Site Plan

M-O-L, Lake County, Ohio

for Russ Gallagher

APPROVED AS NOTED
 CT CONSULTANTS, INC.

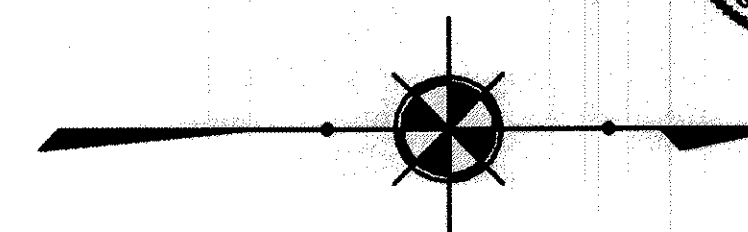
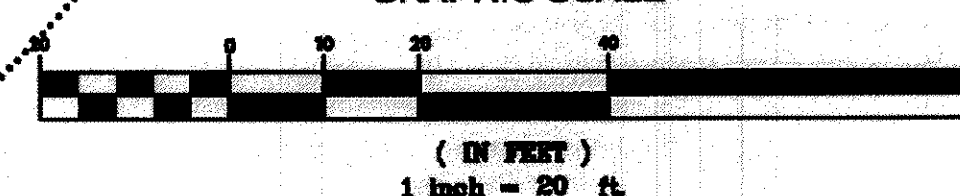
1. PROVIDE WALL DESIGN WITH ENGINEER'S STAMP.
2. DIVERT RUNOFF AWAY FROM GARAGE DOOR.
